**Response to RAIs**

**Highland Uranium Mine and Millsite**

**Request for Amendment to Radioactive Materials License UA-1139**

**April 8, 2013**

CLIENT	ExxonMobil Environmental Services			
PROJECT	HIGHLAND MINE & MILL SITE			
TITLE	SURFACE WATER SAMPLING LOCATION MAP			
amec	DRAWN BY	KMW	CHECKED BY	BW
	FILENAME	677520026	DATE	11/28/12
FIGURE No. HAZ1-2

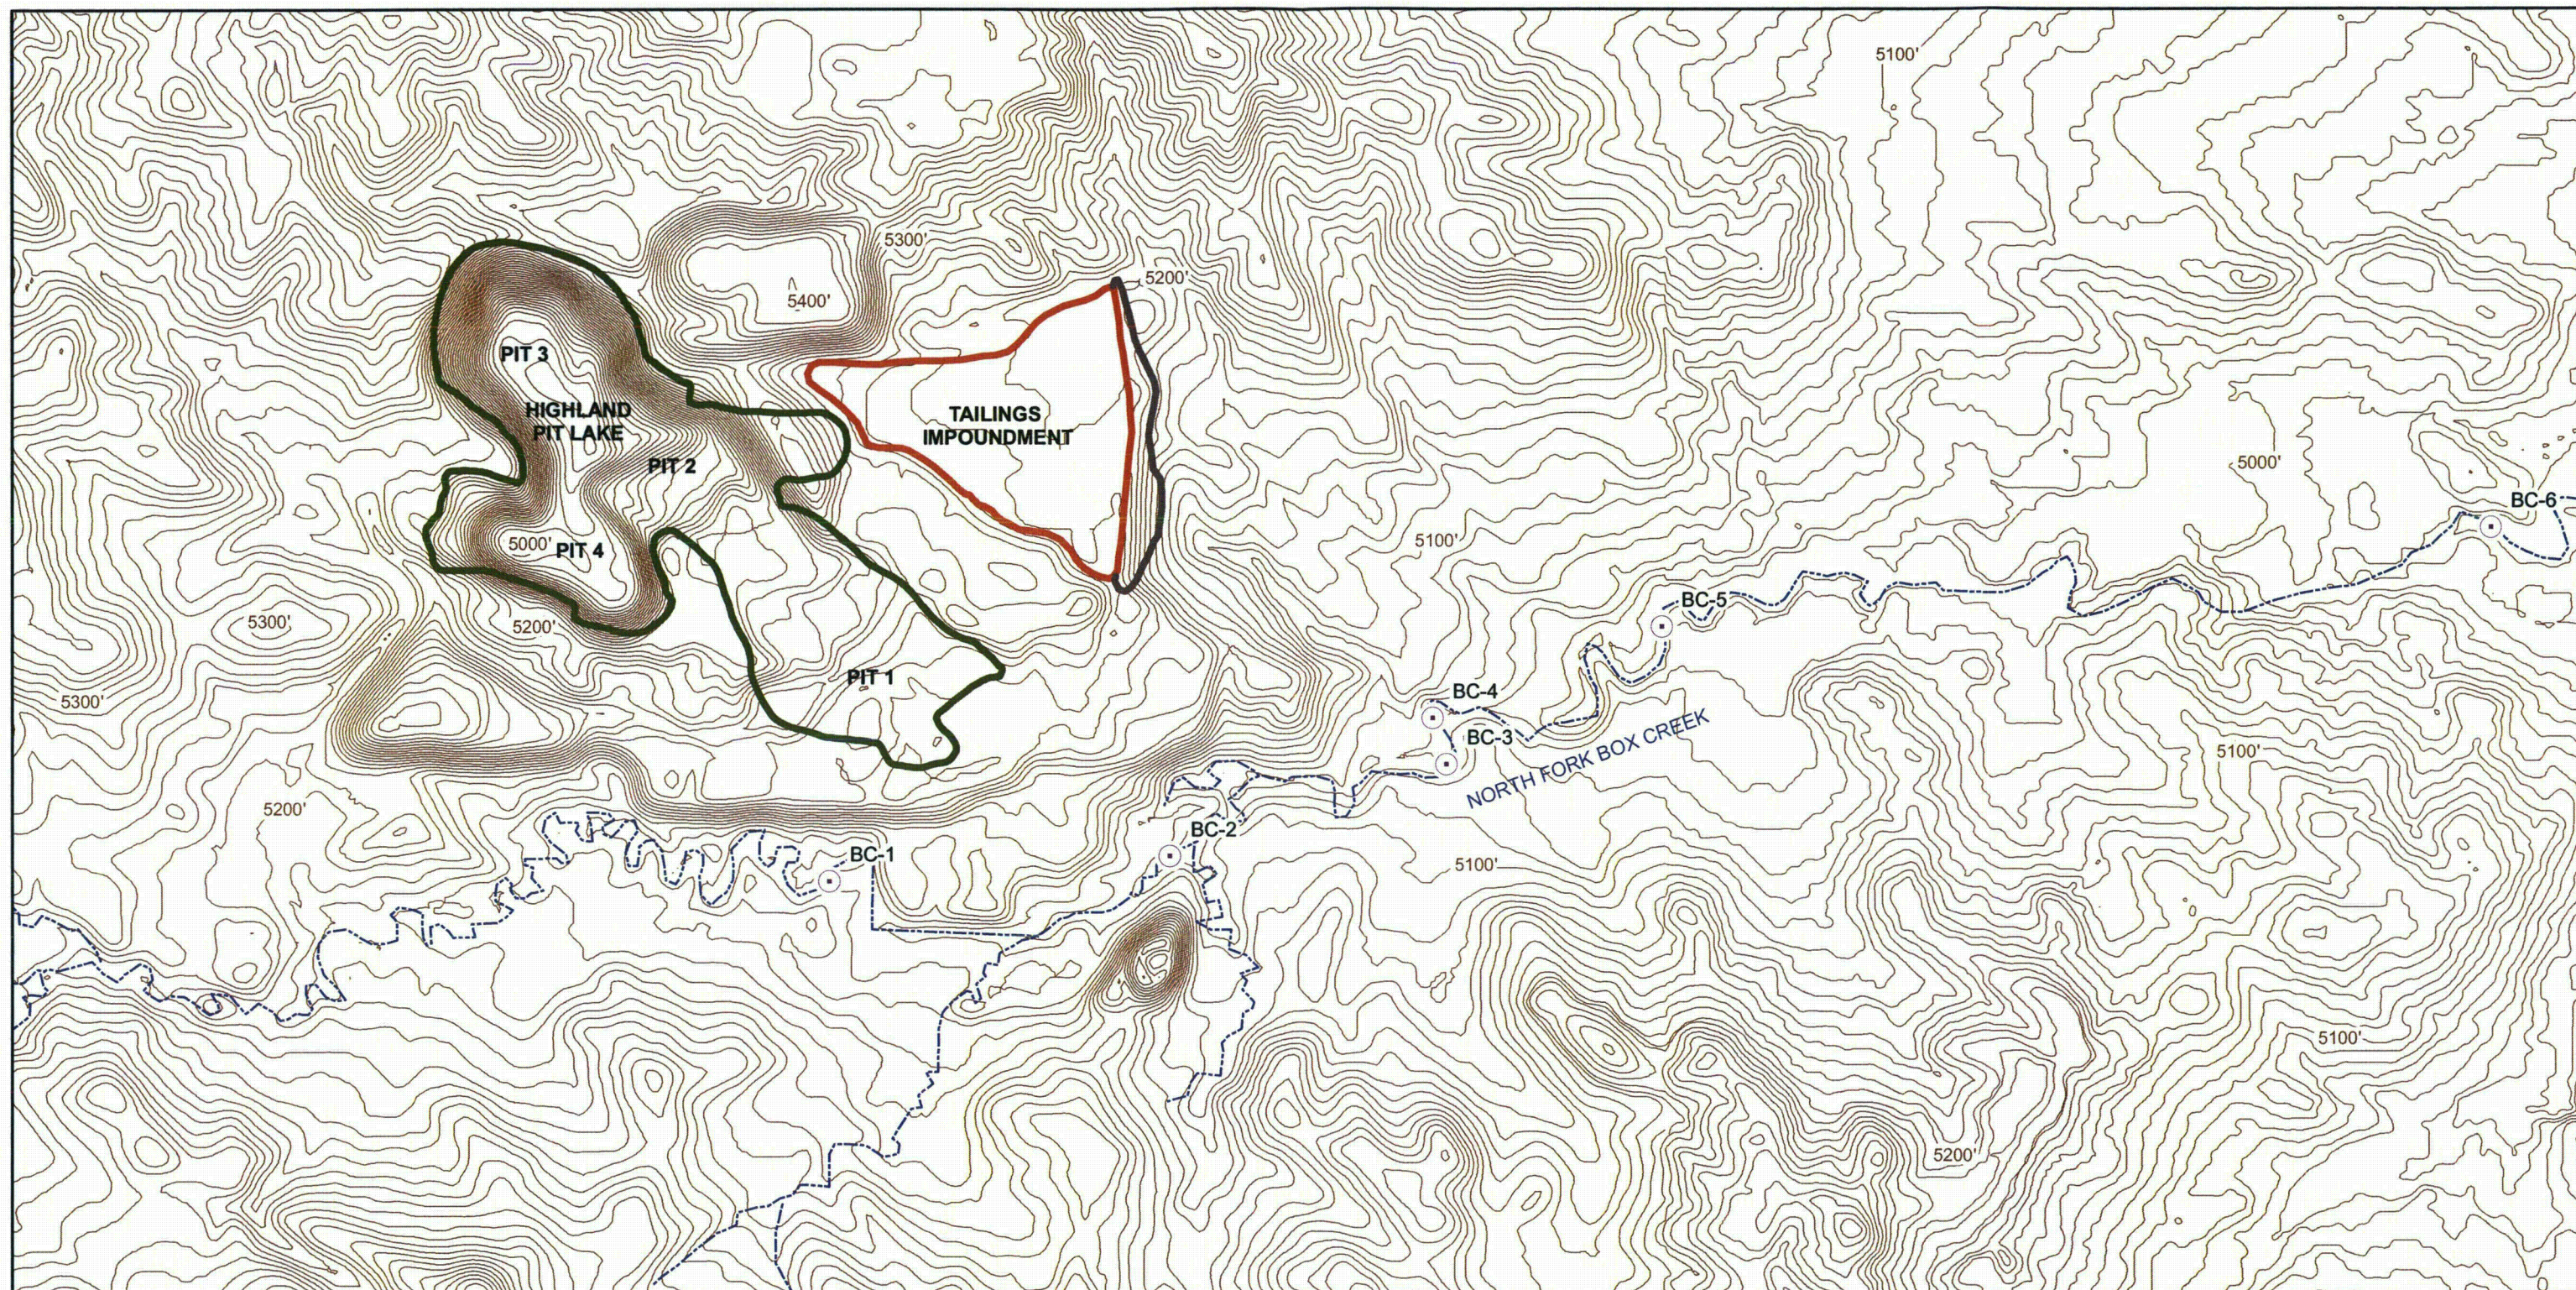
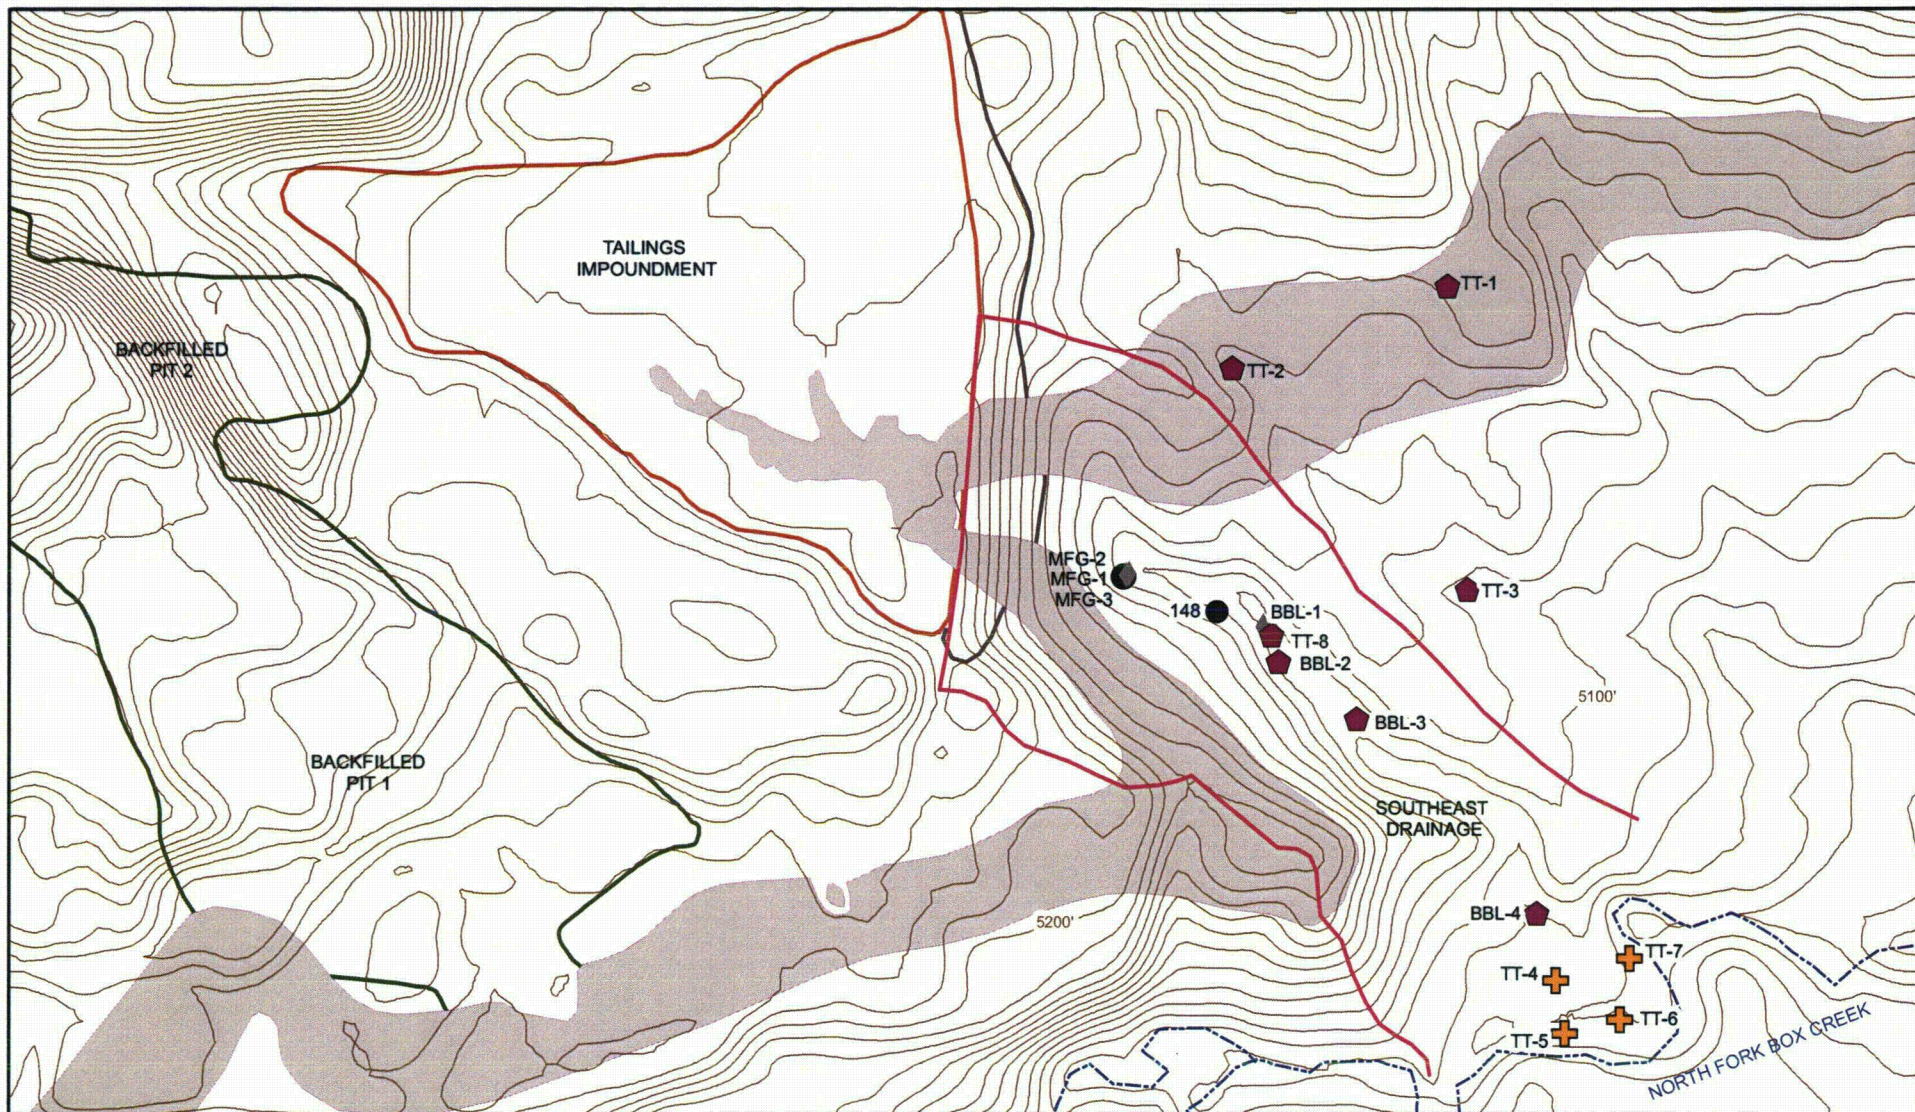
**NRC Staff RAI - HAZ1: Provide the bases for the characterization of the alluvial floodplain as ephemeral and that water quality is affected by biological fouling by giardia and fecal coliform bacteria.**

Additional support comes from the surface water sampling of NFBC that was initiated in August 2008. Surface water samples are collected twice a year, in spring and late summer, from six locations along NFBC (**Figure HAZ-1-2**). The locations selected for sampling are located at sites along NFBC where water tends to pool after flow has ceased. Between pools NFBC is dry except for a short time in early spring. While sample locations were selected at pools, only sample locations BC-4 and BC-6 have been sampled during every sampling event. Sample location BC-1 and BC-3 were dry on one occasion and BC-2 and BC-5 were dry on five and four of the nine total sampling events, respectively.
